DESIGN <i>CP</i>	DRAWN BY <i>CP</i>	DART AEROSPACE LTD HAWKESBURY, ONTARIO, CANADA	
CHECKED <i>#</i>	APPROVED <i>#</i>	DRAWING NO. D3016	REV. A SHEET 1 OF 3
DATE 01.05.18		TITLE SEAT FRAME ASSEMBLY	SCALE NTS
A	01.05.18	NEW ISSUE

DRAWING NO. D3016	TITLE SEAT FRAME ASSEMBLY	REV. A	DART AEROSPACE LTD ENGINEERING ORDER	D.E.O. NO. D3016-A-1	SHEET NO. SHEET 1 OF 1	SCALE NTS
DRAWN <i>1</i>	CHECKED <i>UP</i>	MFG. APPR. <i>RE</i>	APPROVED <i>WAP</i>	DE APPR. <i>WAP</i>		
DATE 10.01.29	DATE 10.01.29	DATE 10.01.29	DATE 10.01.29	DATE 10.01.29	DATE 10.01.29

PURPOSE:

TO REVISE D3016-11 SADDLE'S HOLE SIZES

D3016-11 SADDLE

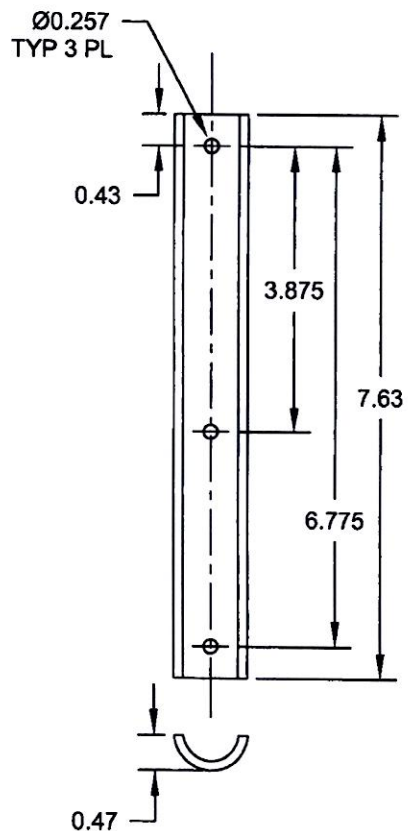
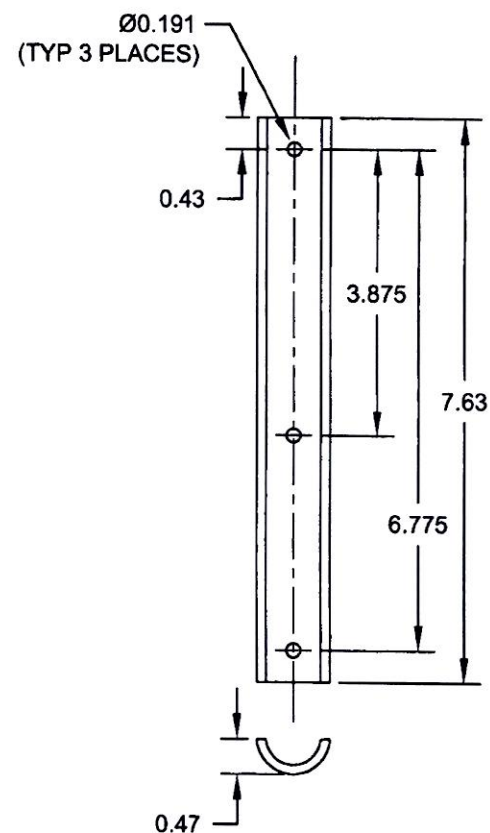
DETAIL D3016-11 SADDLE (SHEET 3): Ø0.257 TYP 3 PL WAS Ø0.191 (TYP 3 PLACES) AS SHOWN:
